Response to Nevada Division of Environmental Protection (NDEP) Comments, dated June 16, 2009, regarding Updated Groundwater Flow Model Calibration BMI Upper and Lower Ponds Area report dated May 14, 2009 NDEP Facility ID# H-000688

FIGURE 7
CONTOUR MAP OF HYDRAULIC
HEAD IN THE MIDDLE ZONE

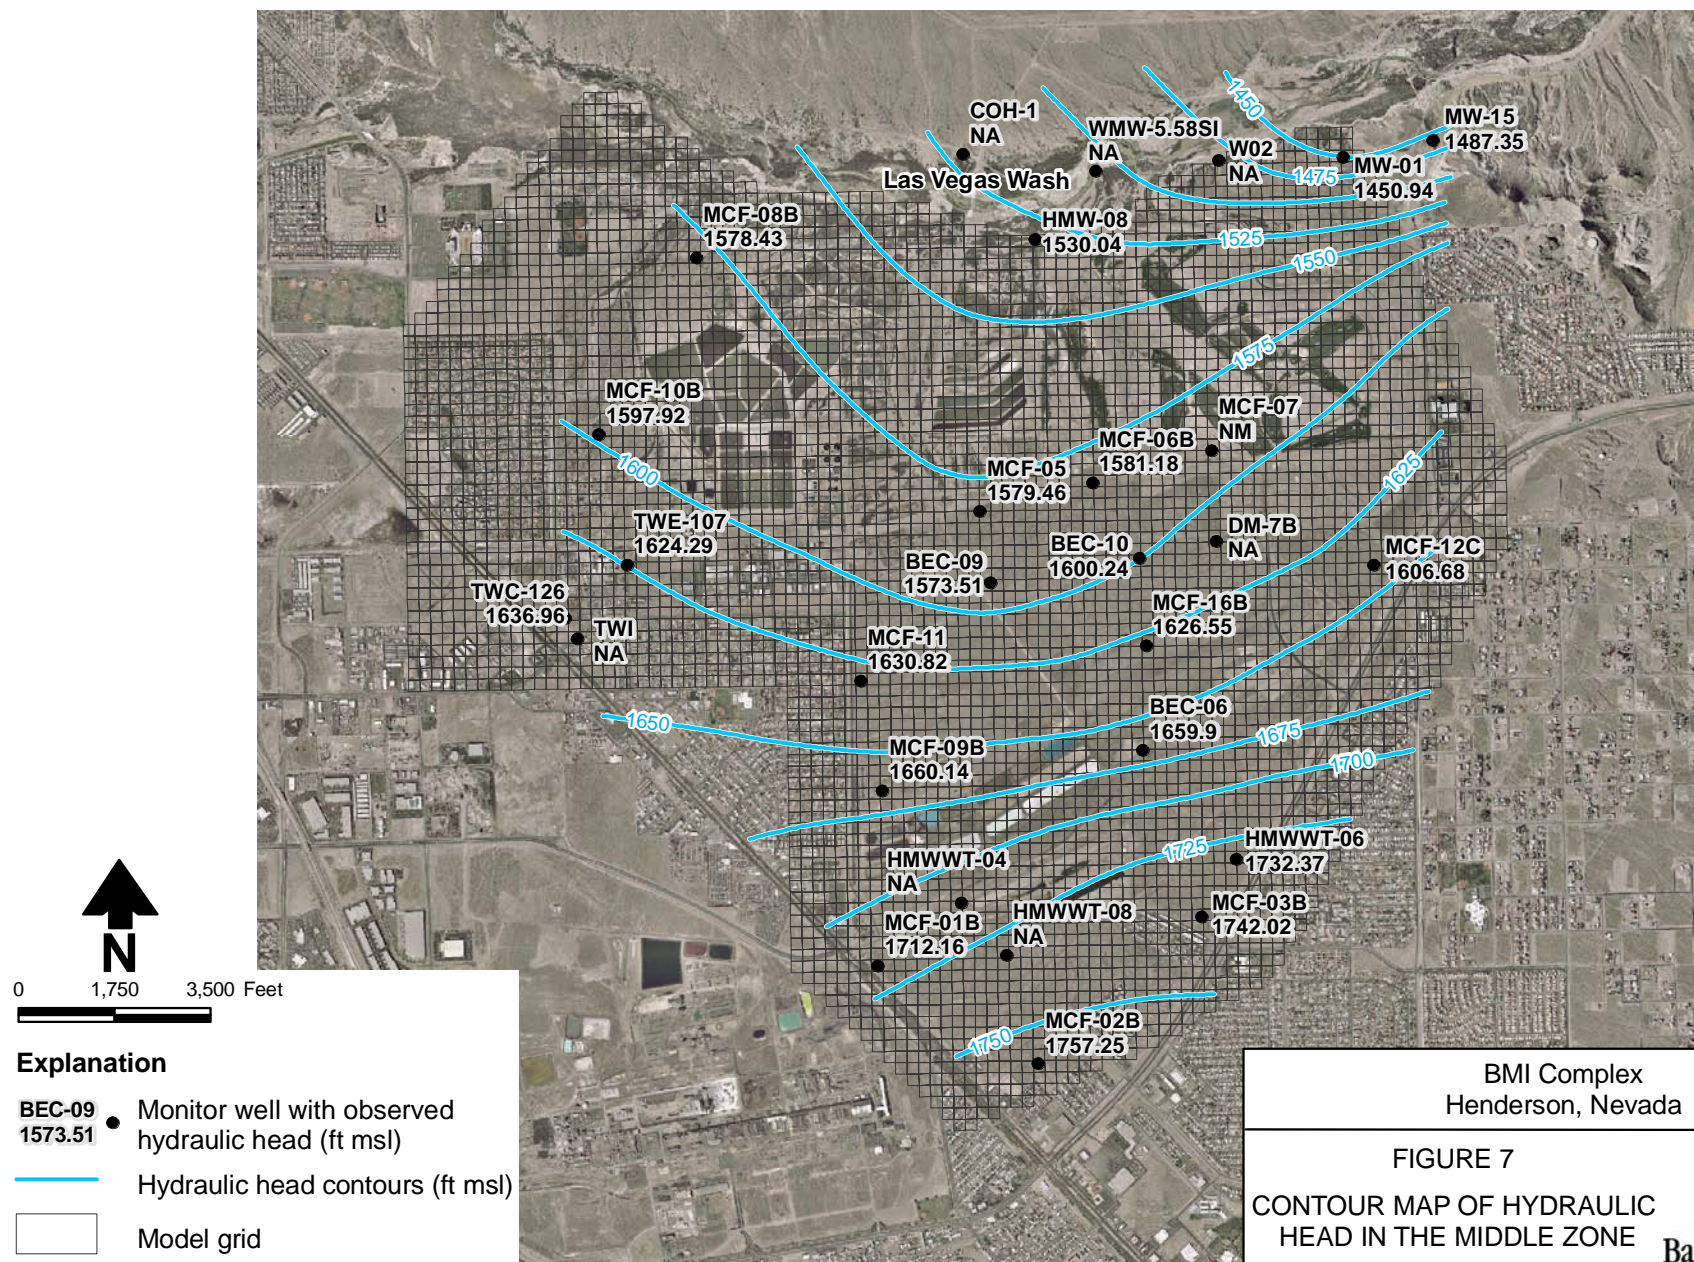
5. Figure 7. Please post wells with hydraulic head for the Middle Zone.
6. Figure 8. Please post wells with hydraulic head for the Deep Zone.
7. Figures 1, 30, and 35. Please refer to comments above on recharge from precipitation.
8. Figure 38. Please identify the Tronox and AMPAC well fields.

Response: New versions of Figures 7, 8 and 38, updated as requested, are provided with this RTC. Figures 1, 30, and 35 are not updated because doing so would require numerous changes throughout the report to maintain consistency, and resubmission of the entire report was not the intent or request of NDEP. Prior to using the model to conduct additional predictive simulations, prescribed recharge will be updated as described under RTC No. 3.
